## EA-2100

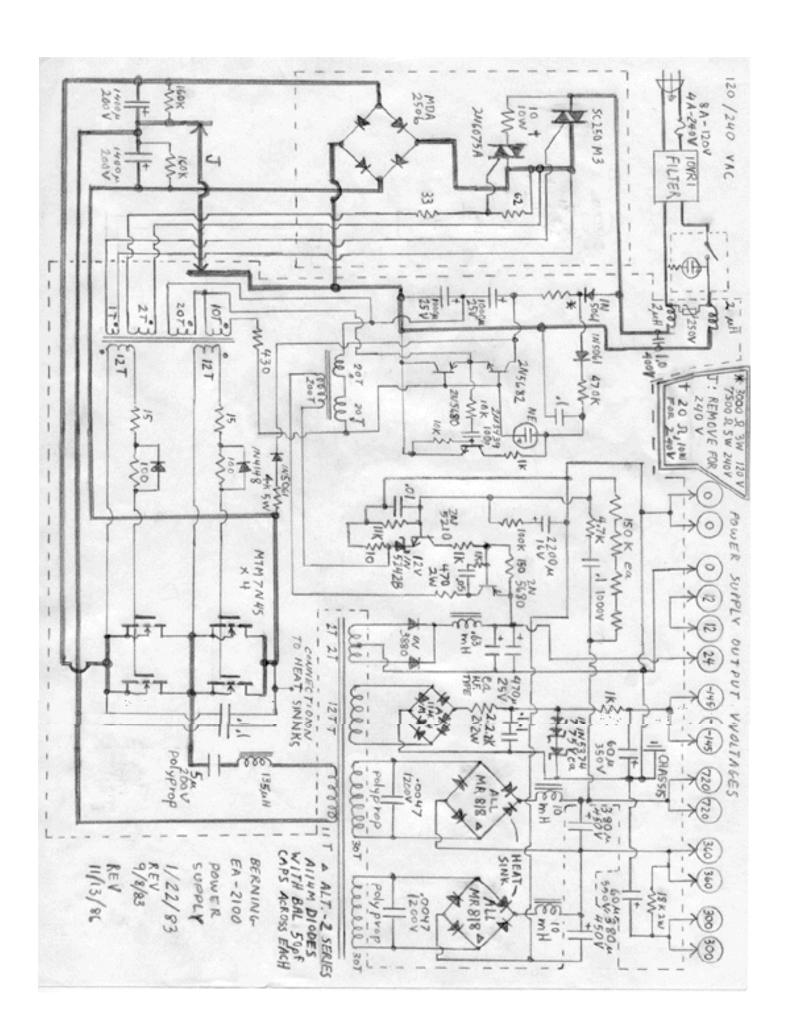
The 6LF6 output tubes have become extremely expensive and hard to find. The Svetlana EL509 is similar in characteristics, and with a substantial amount of work the EA-2100 can be changed to take these tubes. The socket must be changed, requiring a hole to be punched through the circuit board and the new socket to be mounted in the hole. All four tubes must be changed if this modification is attempted.

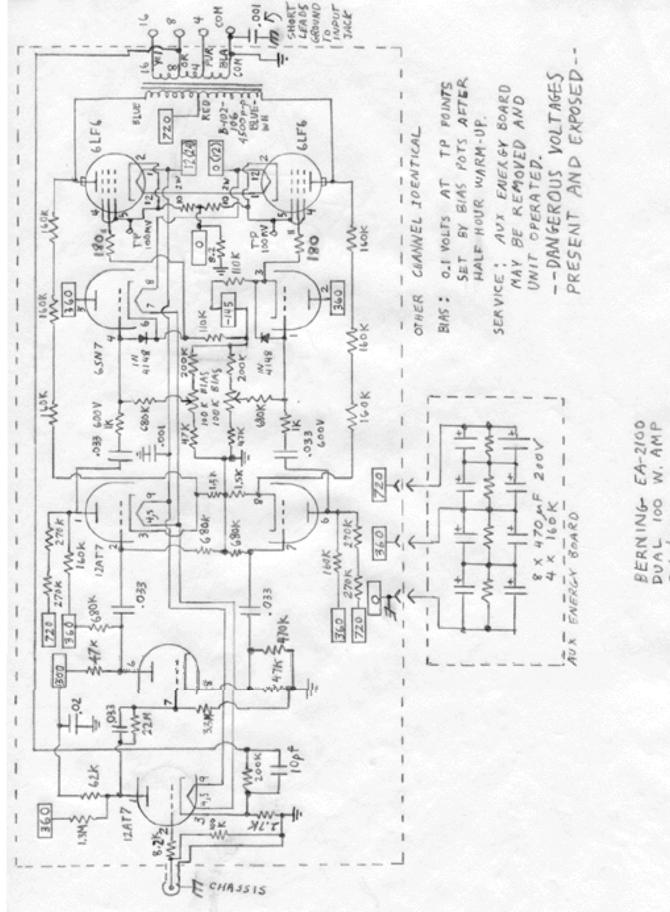
Failure prone parts in this amplifier are the triacs, 10-ohm 10 W soft-start resistor, and the power MOSFETs. These failures occurred early on, as the early MOSFETs had a poorer quality oxide than newer MOSFETs. For replacement purposes, see the schematic for the EA-2101 for newer types of MOSFETs. The TR6421M triac should be used in place of the obsolete SC250M3. Only two (one on each heat sink) of the IRF452s should be used (not four) if the MTM7N45s need to be replaced. The gate diodes and resistors are usually destroyed when the MOSFETs blow. A drop in power line voltage that sometimes occurs in a storm can destroy these parts. The added parts in the oscillator section shown in the schematic for the EA-2101: EC103B SCR, 2N5210 transistor, zener diodes, and other parts associated with these provides protection against low line voltage. These parts could be added to the EA-2100 if this is a recurring problem.

Early versions of this amp used two A114M (600V) diodes in series for each leg of the bridge instead of the single MR818 (1000V) diodes in the bridge rectifiers. These were prone to failure and a mod is to place 100pF-500V capacitors across each diode (16 in all required). If the change is made to single MR818s, heat sinks are required.
